# UNITED STATES PATENT AND TRADEMARK OFFICE

10/575,860

<b>Office Action Summary</b>	<b>Application No.</b> 10/575,860	<b>Applicant(s)</b> KIM, KYU YOUNG	
	<b>Examiner</b> Quang T. Van	<b>Art Unit</b> 3742

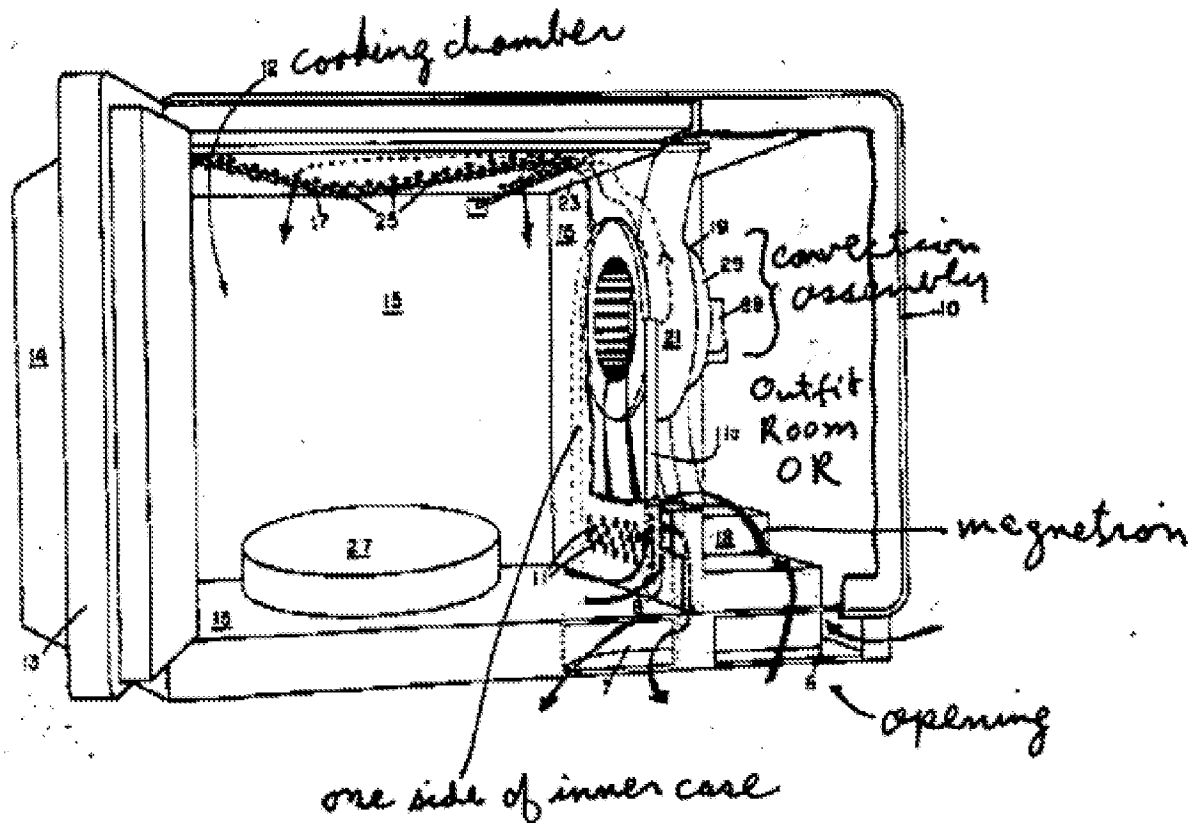
Klapper/Lee disclose substantially all features of the claimed invention, Klapper also discloses a convection assembly mounted at one of the pair of side walls 15 of the inner cases that transmits heat to the cooking chamber 1, wherein the convection assembly comprises: a convection heater 12 configured to generate heat for convection heating; and a convection fan 11 configured to transmit the heat generated by the heater to the cooking chamber, and wherein the convection heater is positioned adjacent the convection fan (see Figures 1 and 2 and the English abstract). However, Klapper/Lee do not disclose the location of the magnetron and the transformer being in the outfit room. Larsen shows a microwave oven comprising: a body 10 forming an outer appearance; an inner case 15 in the body having a cooking chamber 12 formed therein; an outfit room (marked as OR) at one side of the inner case, having various electric parts, (including a magnetron 18, a high voltage transformer 92), mounted therein; and a convection assembly (19, 21, 29) mounted at a side of the inner case, for

transmitting heat to the cooking chamber and a convection heater 17 for generating heat for convection heating (see the marked-up copy of Figure 1 below).
